City Council Communication

Department: Community Development CASE #SUB-22-005 Applicant: HCC Investments, LLC 9101 W 110th Street, Suite 200 Overland Park, KS 66210 Property Owner: HCC Investments, LLC 1473 Abercorn Drive Council Bluffs, IA 51503 Engineer/Surveyor: Ehrhart Griffin & Associates 149 W Broadway Council Bluffs, IA 51503	Ordinance No. _____ Resolution No. _____	City Council: 4/25/2022 Planning Commission: 4/12/2022

Request: Preliminary plan approval for a 58-lot residential subdivision, to be known as Hills of Cedar Creek Central Phase 2, being legally described as a portion of the NW ¼ SE ¼, a portion of the NE ¼ SE ¼, a portion of the SW ¼ SE ¼, all lying in Section 34, Township 75 North, Range 43 West of the 5th Principal Meridian, and all of outlot 'R', The Hills of Cedar Creek Phase 2, Council Bluffs, Pottawattamie County, Iowa.

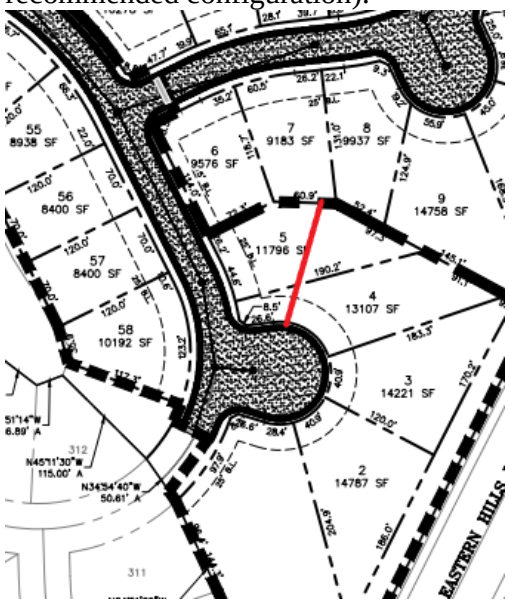
1. The applicant shall coordinate with Public Works on final street design, stormwater management, grading, and utilities as necessary to comply with City standards.
2. The "future road" that extends west of the proposed Ballard Circle extension shall be extended to the rear property line of Lot 45, and a temporary emergency vehicle turnaround shall be provided at the end of this street segment. Temporary turnarounds shall also be provided at the intersections between the proposed Ballard Circle and Hampton and Quenby Drives before construction begins on Phase 2 of the proposed subdivision.
3. Lots 4 and 5 shall be reconfigured such that both lots front the cul-de-sac (see figure below for approximate recommended configuration).

7. Lots 4 and 5 shall be reconfigured on the final plat such that each lot has frontage on the cul-de-sac, as shown in the comments from Public Works.
8. The "future road" that extends west of Ballard Circle between proposed Lots 45 and 46 shall be extended to the rear lot line of Lot 45 and shall be built to include a temporary emergency vehicle turnaround. Temporary turnarounds shall also be provided at the intersections between the proposed Ballard Circle and Hampton and Quenby Drives.
